SWIM PROJECT PROFILE		File No. : 100
Regist. No. : Agency No. : BSWM-10	Name: PAMARANUN SWIP	
Region: 1	Province: PANGASINAN	Municipality: MALASIQUI
Present Status: 1. Pre-F/S() ② F/S(1983) ③ D/D(1983)		
Purpose: Major : Irrigation Incidental : IF, FC, WM		
Project Feature:

SWIM PROJECT PROFILE		File No. : 101
Regist. No. : Agency No. : BSWM-11	Name : CAPARISPISAN SWIP	
Region : 1	Province : ILOCOS NORTE	Municipality : PAGUDPUD
Present Status : 1. Pre-F/S() ② F/S(1983) ③ D/D(1983)		
Purpose: Major : Irrigation Incidental : IF, FC, WM		
Project Feature:

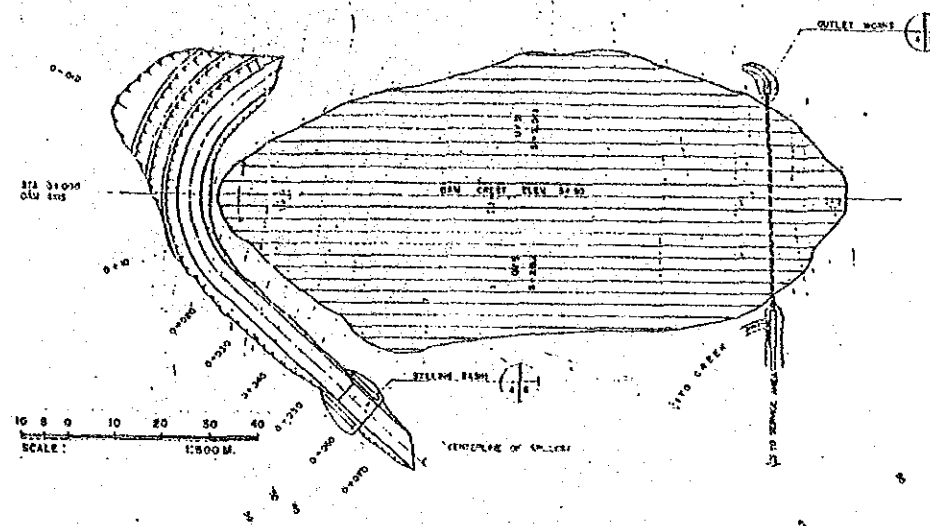
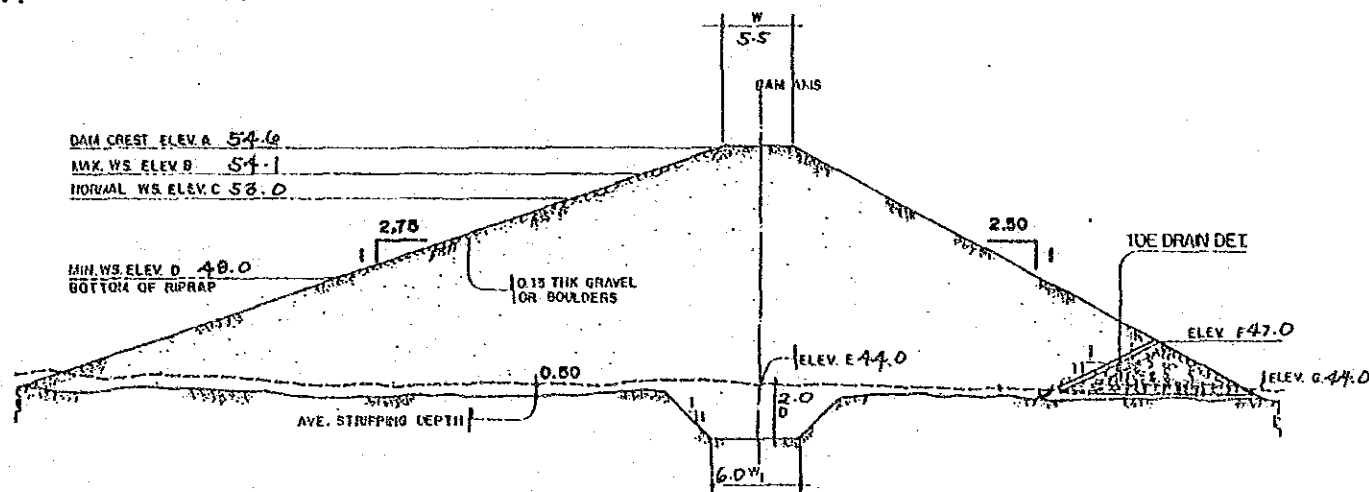
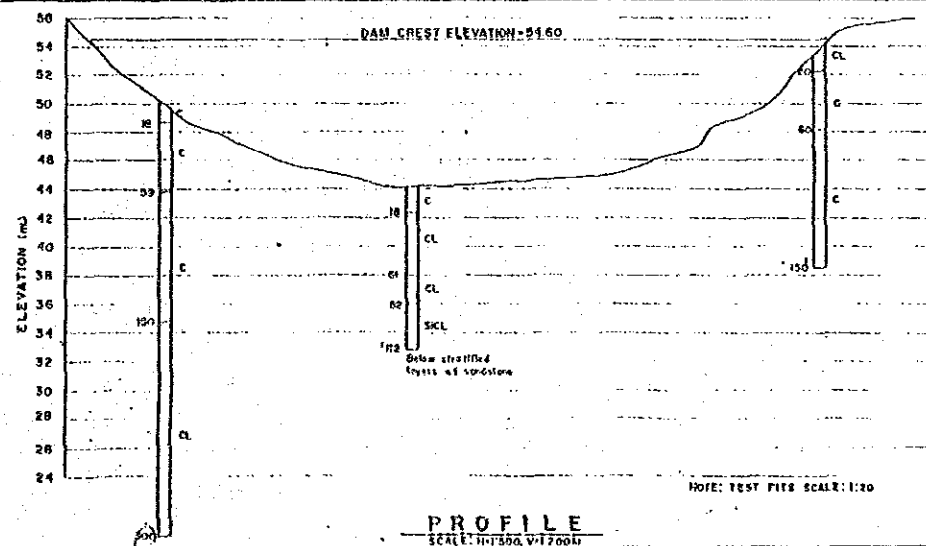
2. Planning Environmental conservation plan is not formulated.		
3. Design Depth of core trench shall be modified during construction. Stability of upstream slope of the dam shall be checked. Freeboard is not enough. Weir shall be provided in the spillway.

Silty clay with 3.0 m depth covers the sand stone and shale. Additional 0.5 m freeboard is necessary.

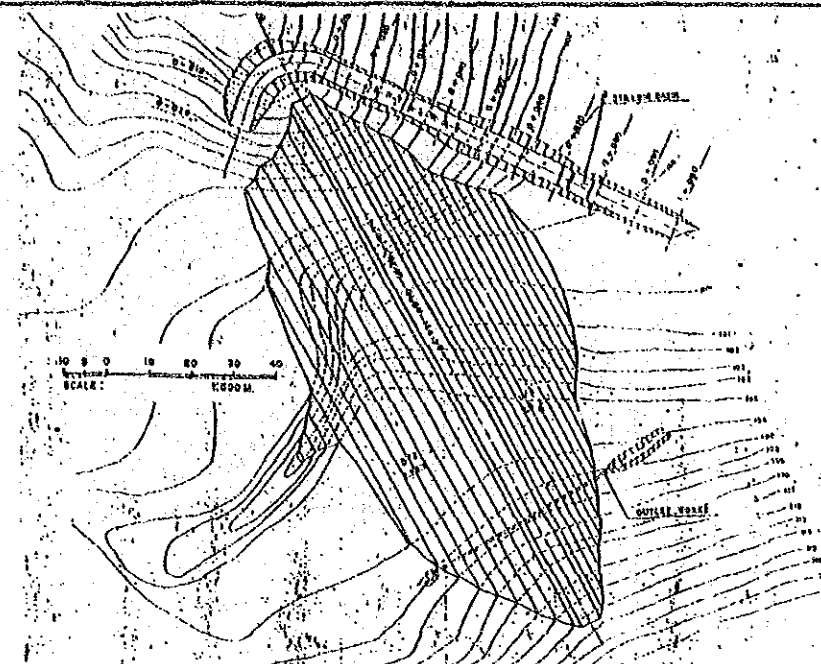
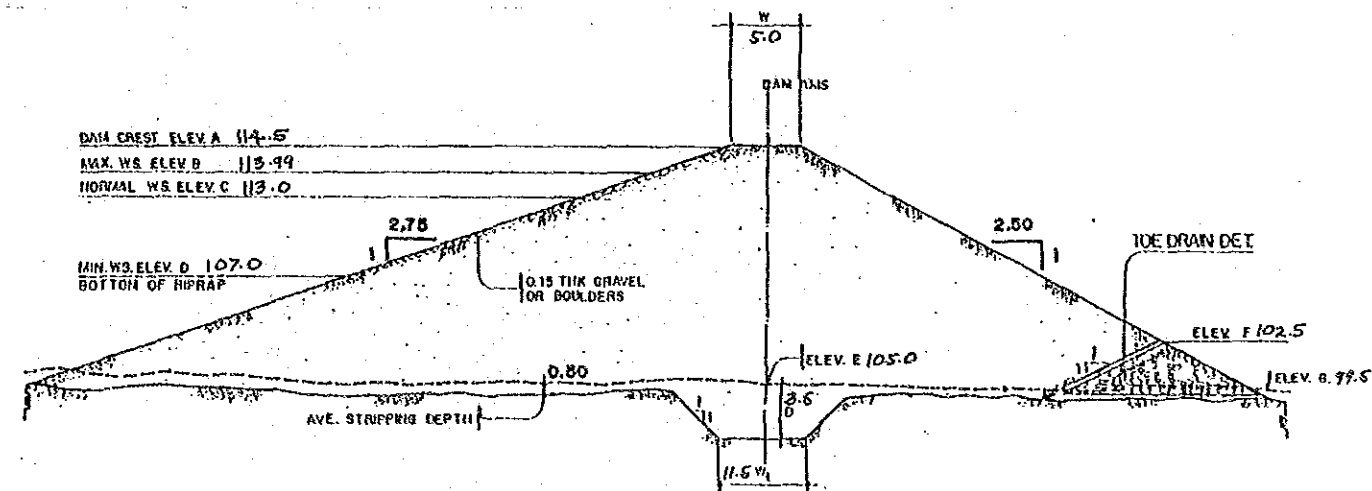
2. Planning Environmental conservation plan is not formulated.		
3. Design Depth of core trench shall be modified during construction. Stability of upstream slope of the dam shall be checked. Weir shall be provided in the spillway. Magnitude of design discharge is very less.

Silty clay with 1.0 m depth covers the sand stone, shale and silty stone. Magnitude of design discharge should be more than 100 years flood.

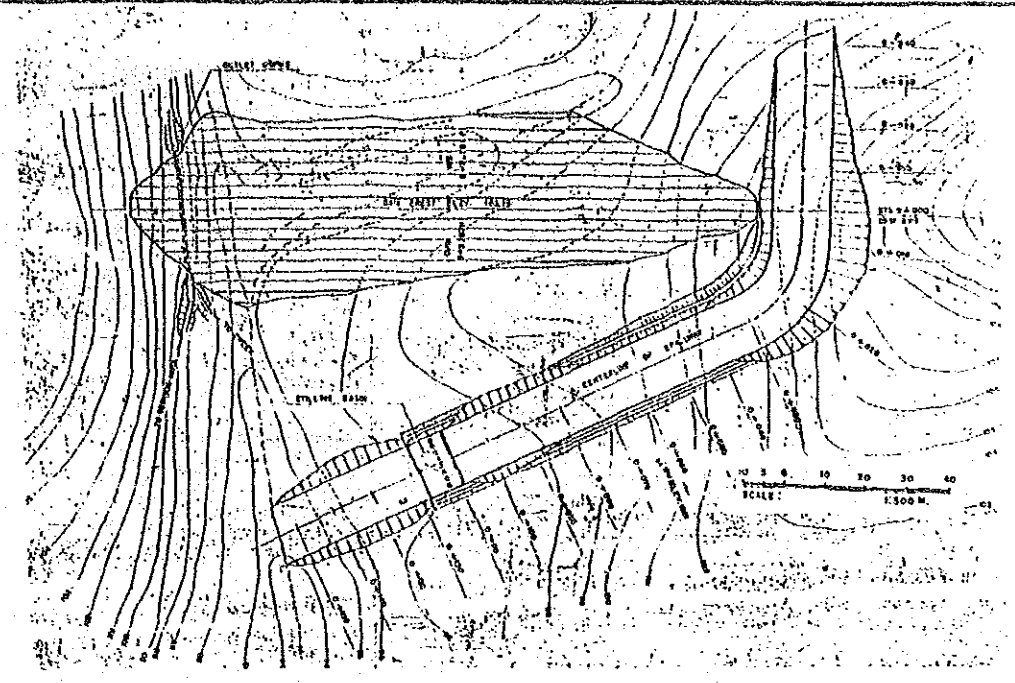
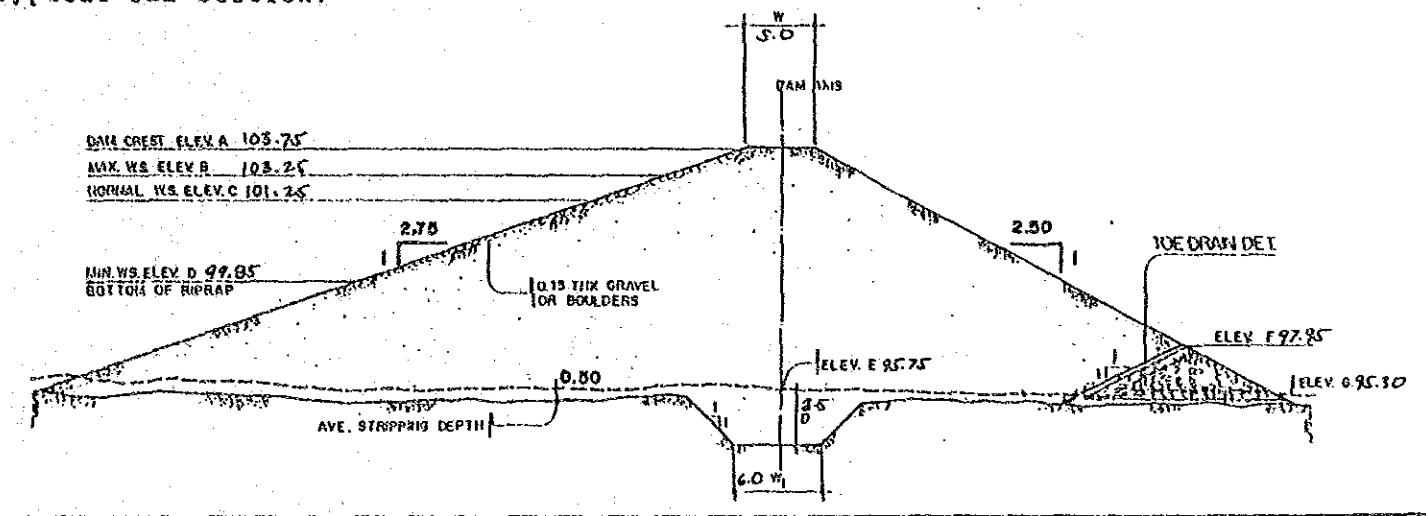
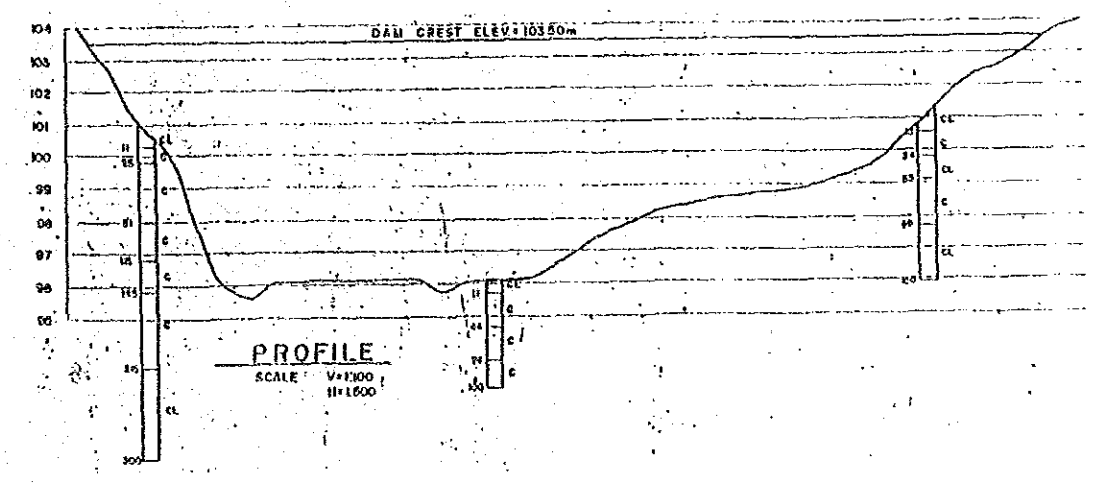
2. Planning Environmental conservation plan is not formulated.		
3. Design Depth of core trench shall be modified during construction. Stability of upstream slope of the dam shall be checked. Freeboard is not enough. Weir shall be provided in the spillway. Center line of the spillway shall be shifted to left side.

Note: Silty clay with 1.0 m depth is piled up on the sand stone. Additional 0.5 m freeboard is necessary.

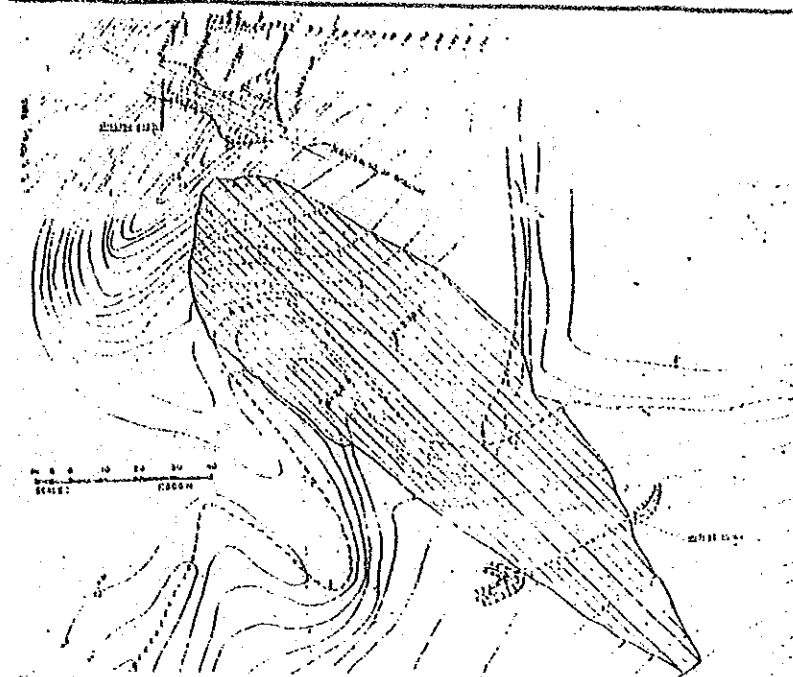
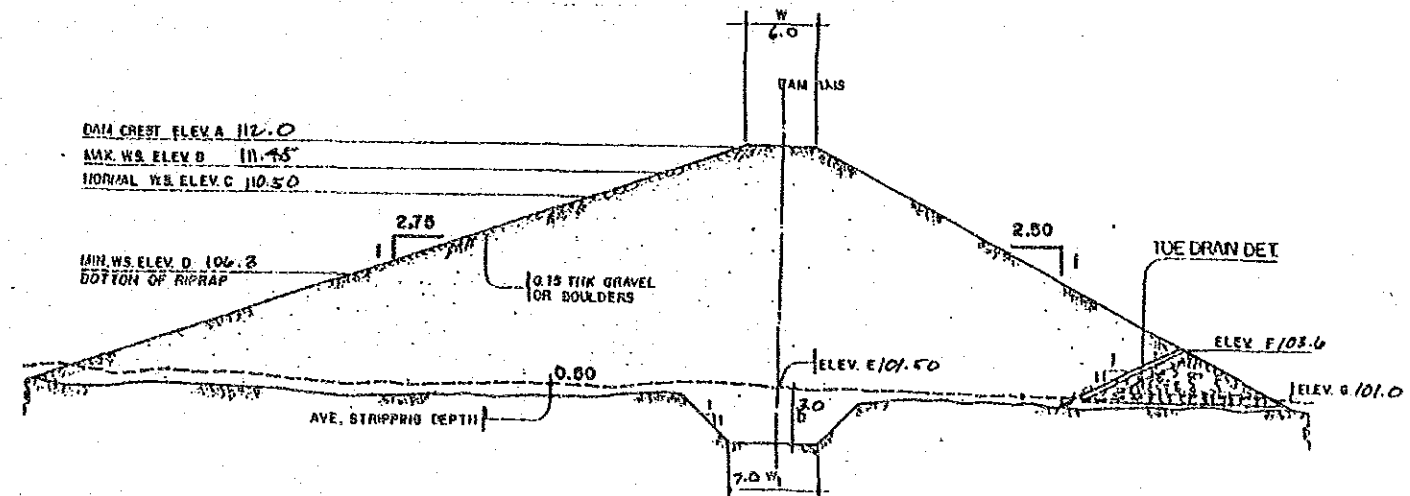
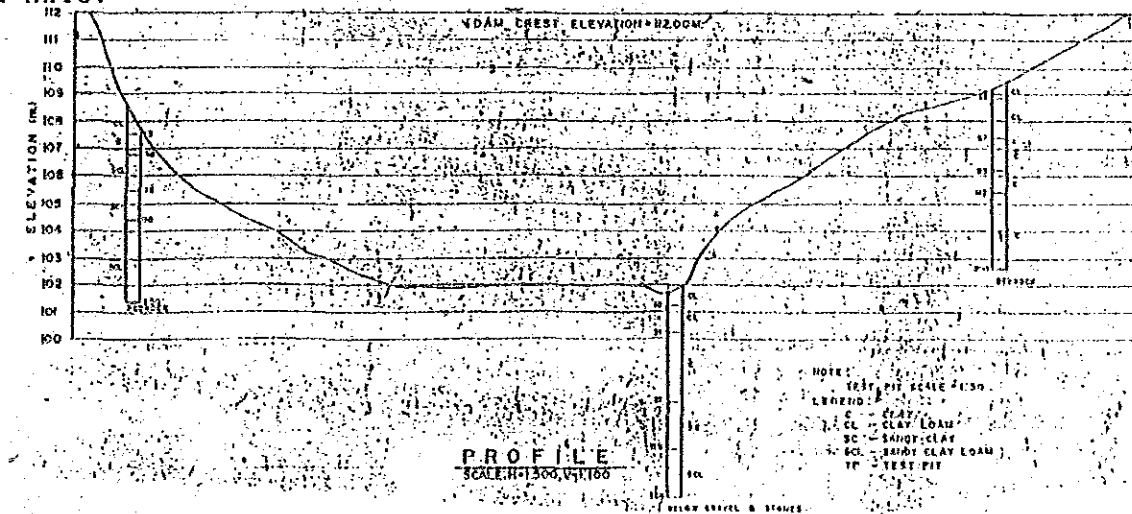
2. Planning		
Environmental conservation plan is not formulated.		
3. Design		
Depth of core trench shall be modified during construction.		
Stability of upstream slope of the dam shall be checked.		
Freeboard is not enough.		
Weir shall be provided in the spillway.

Silty clay with 1.5-2.0 m depth is piled up on the sand stone and shale. Additional 0.5 m freeboard is necessary.

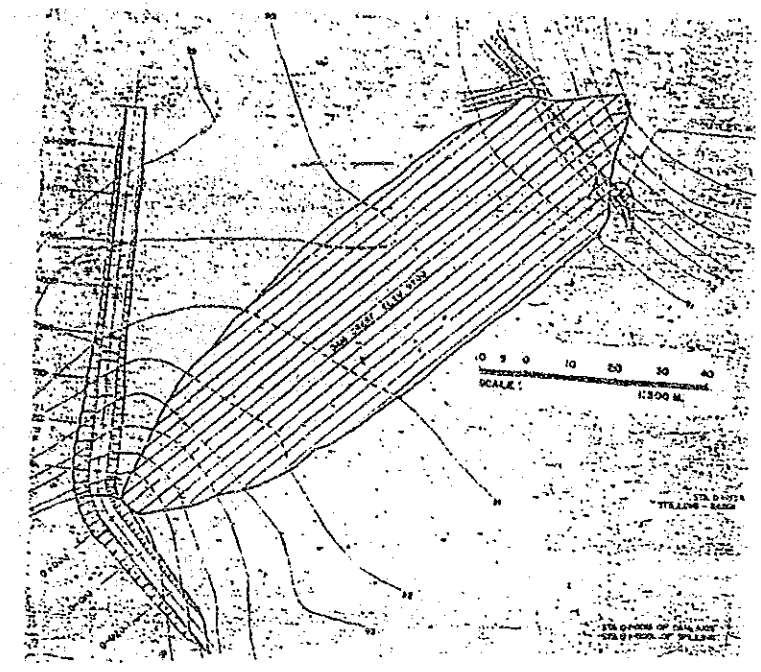
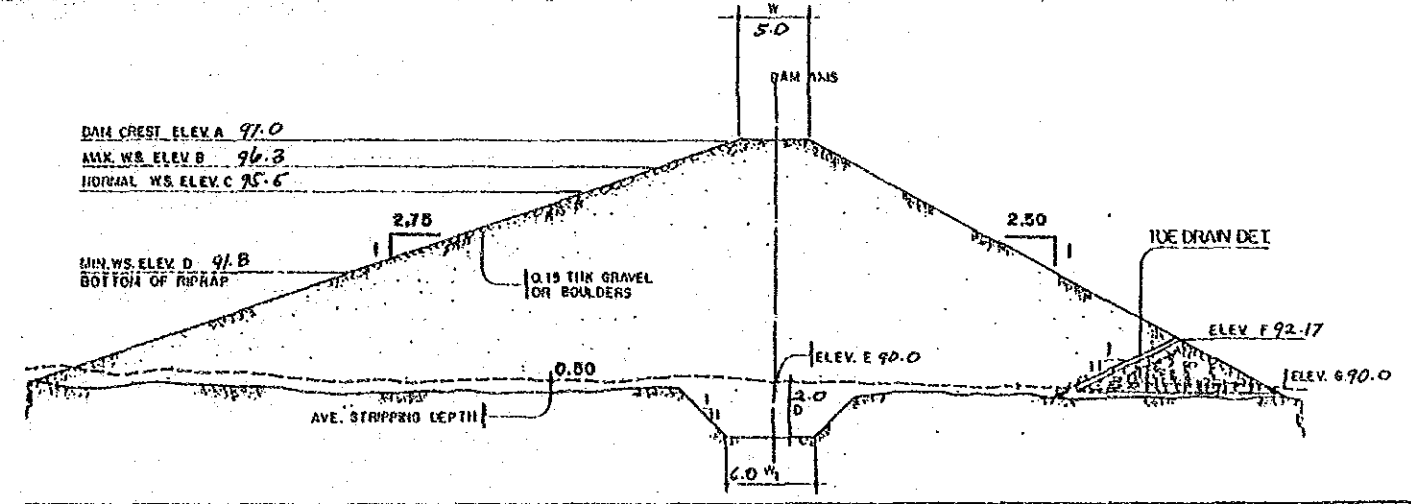
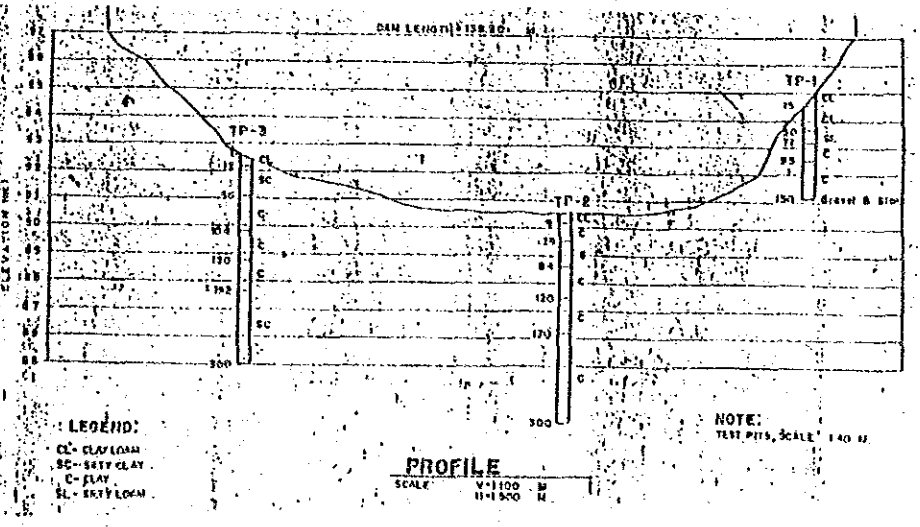
2. Planning Environmental conservation plan is not formulated.		
3. Design Depth of core trench shall be modified during construction. Stability of upstream slope of the dam shall be checked. Freeboard is not enough. Center line of the spillway shall be shifted to left side. Weir shall be provided in the spillway.

Note: Silty clay with 3.0 m depth is piled up on the sand stone and shale. Additional 0.5 m freeboard is necessary.

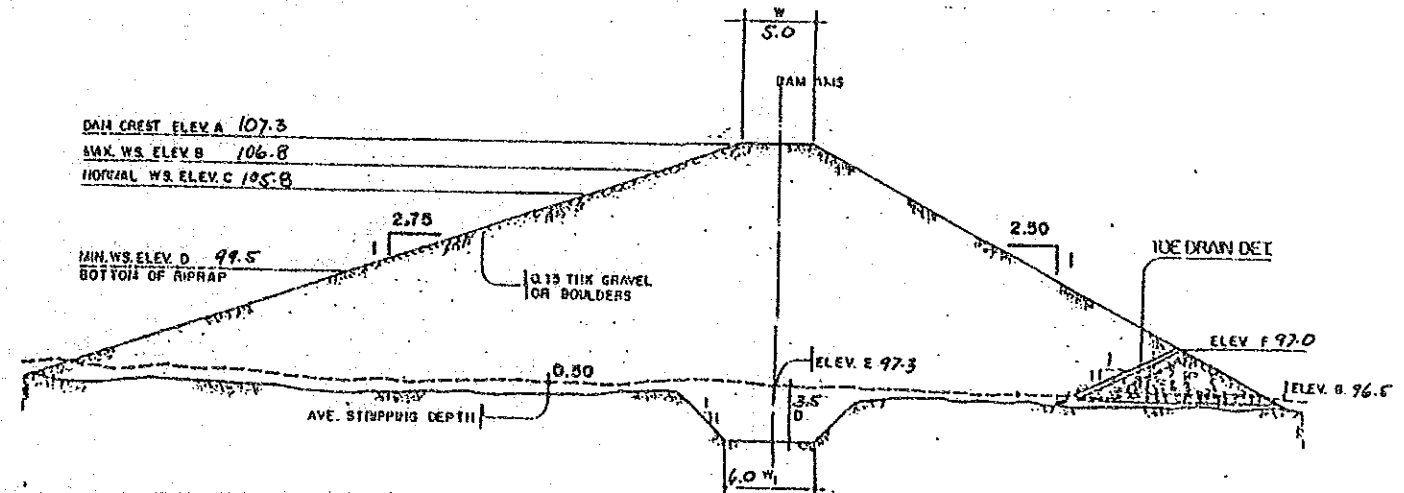
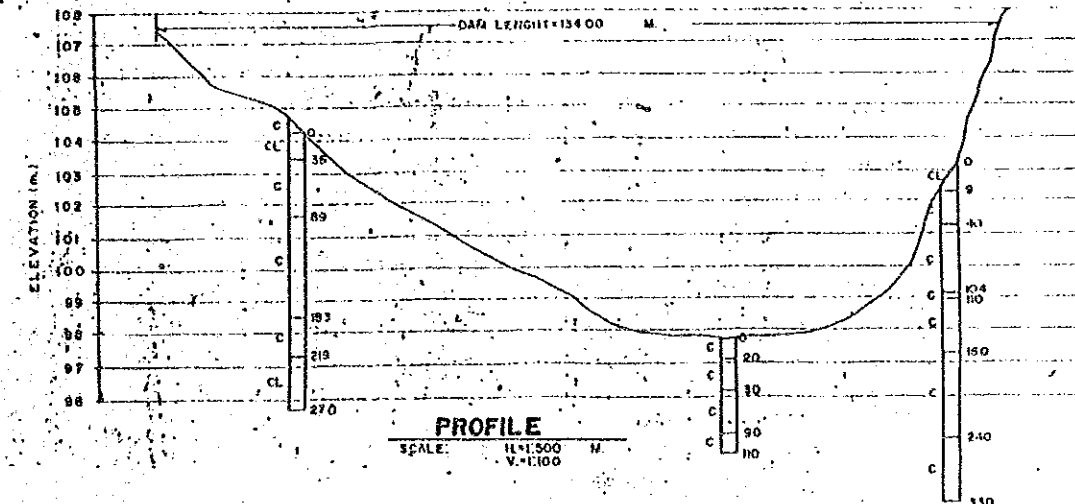
2. Planning		
Environmental conservation plan is not formulated.		
3. Design		
Depth of core trench shall be modified during construction.		
Stability of upstream slope of the dam shall be checked.		
Freeboard is not enough.		
Weir shall be provided in the spillway.		
Center line of conduit is recommended to be straight.

Note: Silty clay with 1.5 m depth is piled up on the metamorphic shale. Additional 1.0 m freeboard is necessary.
